# **A G E N D A**

## **Architectural Review Board**

**February 28, 2023 – 5:30 p.m.**

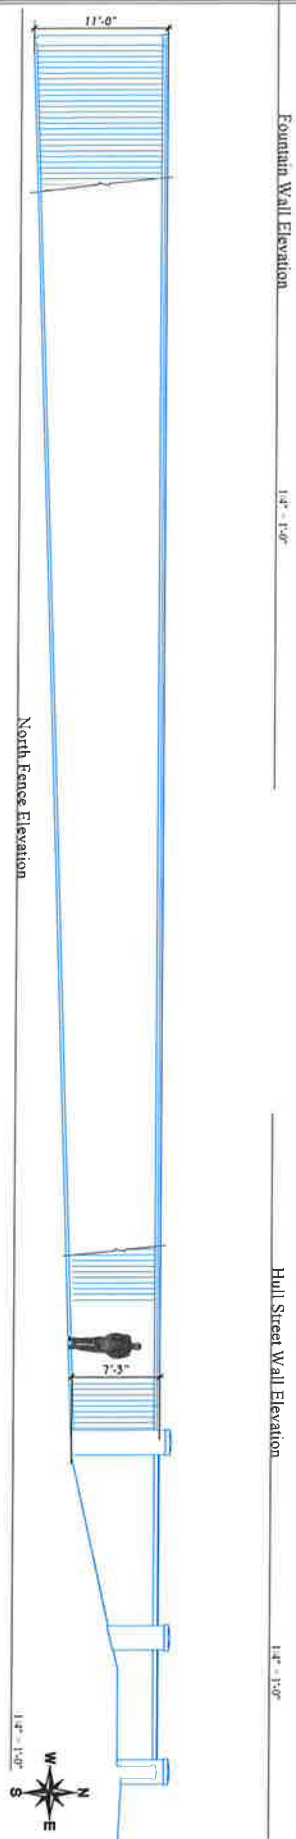
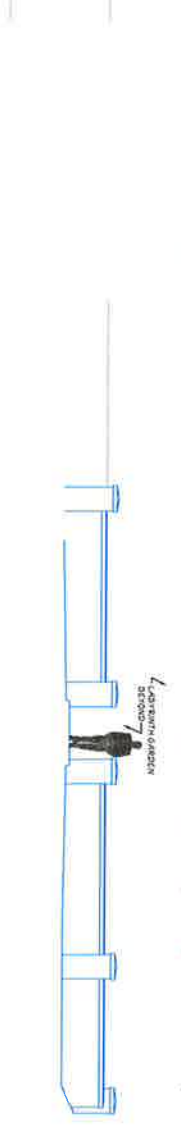
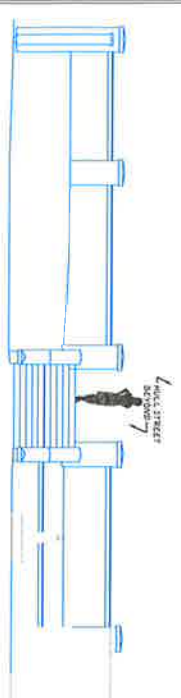
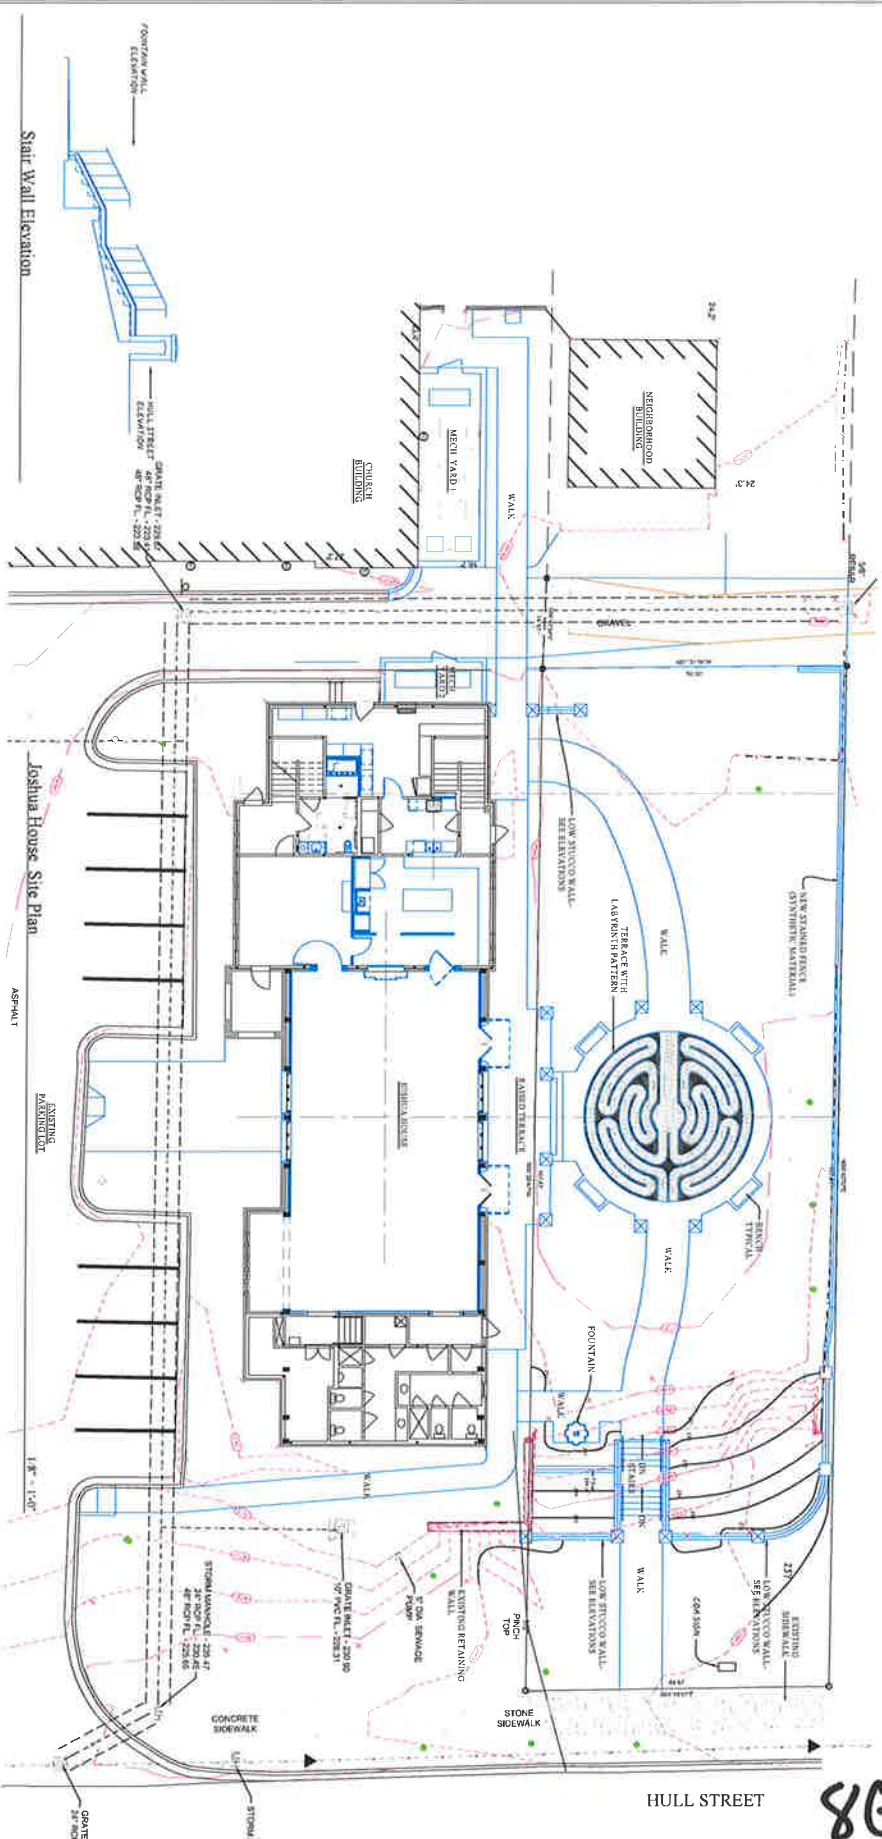
**REMARKS:** The petitioner is requesting permission for the following: a garden space with paved terrace containing a labyrinth pattern, grading, low, stucco retaining walls with cast stone caps, aggregate concrete walks and stairs, mechanical equipment walls, a 10' stained, pre-finished Hardi Trim fiber-cement board that's 3/4" thick fence (to replace the existing), a fountain and a raised bluestone terrace along the north face of the Joshua House. Exterior improvements to the Joshua House include new windows to match existing on the north and south sides, a new 10' tall wood-clad French doors on the north side. The doors will have simulated true divided lites/glass (interior and exterior grills and internal spacer bars in the insulated glass), and custom ornamental iron canopies with copper roofs will be added at the new and existing doors. The trees proposed to be removed are a large water oak, a ginkgo, sycamore and river birch.

- Trees on site are healthy with good form
- Removal of the large trees will have a significant impact on the character of the property.
